# Product Change Notice (PCN)

**PCN Number:** PCN-0456170R-01

Product(s) Affected: *PJ-031D*

PREVIOUS CUI DEVICES DETAIL / IMAGE	NEW CUI DEVICES DETAIL / IMAGE

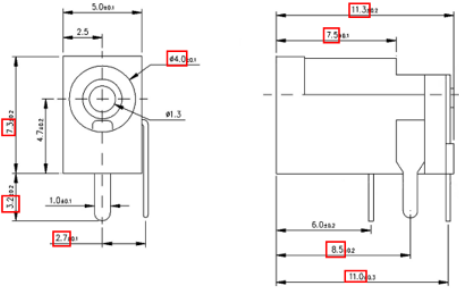
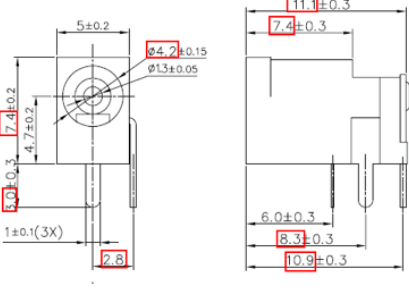
Description of Change: *Product re-engineered for improved manufacturability and production yield. See image below for product changes. Cosmetic differences may be visible and not affect the form fit and function of the product.*

<p>Recommended PCB Layout Top View</p>	 <p>Recommended PCB Layout Top View</p>

PREVIOUS CUI DEVICE'S DETAIL / IMAGE			NEW CUI DEVICE'S DETAIL / IMAGE		
DESCRIPTION	MATERIAL	PLATING/COLOR	DESCRIPTION	MATERIAL	PLATING/COLOR
center pin	brass	silver	center pin	brass	CuSn
terminal 1	brass t=0.50	silver	terminal 1	brass t=0.40	silver
terminal 2	MM alloy t=0.20	silver	terminal 2	stainless steel t=0.20	silver
terminal 3	brass t=0.50	silver	terminal 3	brass t=0.40	silver
housing	PA10T (UL94V-0)	black	housing	PA10T (UL94V-0)	black
<p><b>MATING PLUG</b> Jack Insertion Depth: 7.0 mm</p>			 <p><b>MATING PLUG</b> Jack Insertion Depth: 6.2 mm</p>
